Engineering Bulletin – USA Super 3 Pedal Box Removal/Alteration & Refit[L][L] – Morgan TechHub

## Super 3 – Pedal Box Alteration Procedure

Y191073 - Serrated Washer

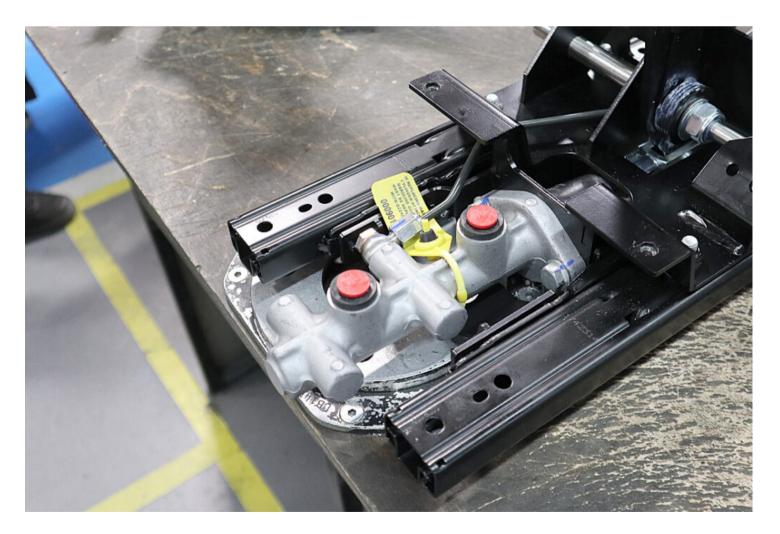
The Serrated Washer is located here on the supplied Pedal Box Assembly for shipping purposes. This will need to be removed prior to assembly.

The Circlip is located here on the supplied Pedal Box Assembly for shipping purposes. This will need to be removed prior to assembly. The nut holding the Circlip can be deposed of as not required.

Prior to starting the Pedal Box Alteration Procedure the following parts must be removed from the supplied Pedal Box Assembly (as per the picture opposite):

- Y191073 Serrated Washer.
- U590003 Circlip 8×1 Steel Type E Flat.
